Access Compliance Report

Public Rights-of-Way

Intersection ID: 46693	Main Street: GOLDFIELDS_DR	Cross Street: OLD_MEADOW_RD	Location: SE
ADA ID: A3176BFCA7FD	Ramp Type: BlendTrans2	Initial Pass/Fail: Fail	Overall Compliance: No
		Severity Score: 21.25

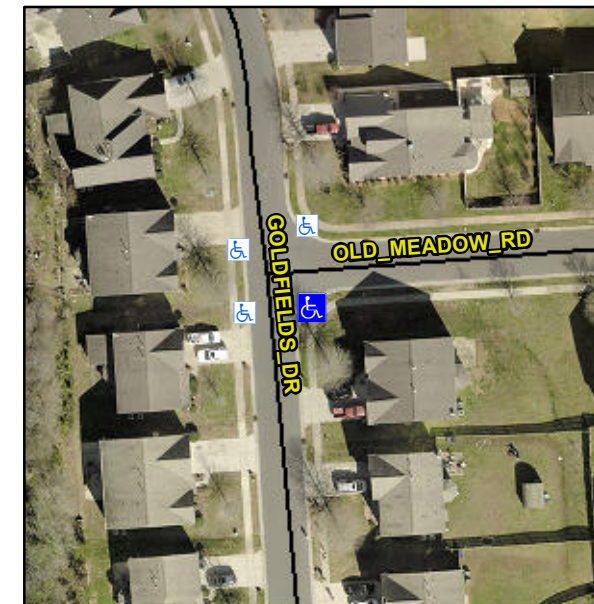
Not Found, R304.5.1, R304.5.3

Compliance	Description	Data	Compliance	Description	Data
N/A	Ramp Length (in)	95.0	Yes	BlendTrans Slope (%)	3.3
No	Ramp Width (in)	43.0	No	BlendTrans XSlope (%)	5.7
N/A	Flare Type LT	N/A	N/A	Flare Type RT	N/A
N/A	Flare Slope LT (%)	N/A	N/A	Flare Slope RT (%)	N/A
N/A	Flare Traversable LT?	N/A	N/A	Flare Traversable RT?	N/A
N/A	Landing Length (in)	N/A	N/A	DWS Provided?	N/A
N/A	Landing Width (in)	N/A	N/A	DWS Contrast?	N/A
N/A	Landing Slope (%)	N/A	N/A	DWS Length (in)	N/A
N/A	Landing X Slope (%)	N/A	N/A	DWS Full Width?	N/A
N/A	Landing Curb? (Y/N)	N/A	N/A	DWS Offset (in)	N/A
N/A	Shared Landing?	N/A			
N/A	Gutter Ponding?	N/A	N/A	Gutter Slope (%)	N/A
N/A	Gutter Lip Ht (in)	N/A	N/A	Gutter X Slope (%)	N/A
N/A	Painted X Walk1?	No	N/A	Painted X Walk2?	No
	X Walk 1 Direction	To N		X Walk 2 Direction	To W
	X Walk 1 Width (in)	N/A		X Walk 2 Width (in)	N/A
	X Walk 1 Slope (%)	4.9		X Walk 2 Slope (%)	3.0
	X Walk 1 X Slope (%)	0.8		X Walk 2 X Slope (%)	3.0

N/A	Ramp inside XWalk1?	N/A	N/A	Ramp inside XWalk2?	N/A
	Road Slope (%)	1.5		Clear Space?	N/A
	Road X Slope (%)	6.9	N/A	Clear Space to XWalk (in)	N/A
N/A	Any Obstructions?	N/A	N/A	Storm Grate/Utility Hazard?	N/A
	Obstruction Type			Storm Grate/Utility Type	
		N/A			N/A
			Yes	Surface Condition? (G/P)	Good
			No	Curb Slope (%)	9.9

Remove & Replace Curb Ramp With Two New Directional Ramps or Equivalent.
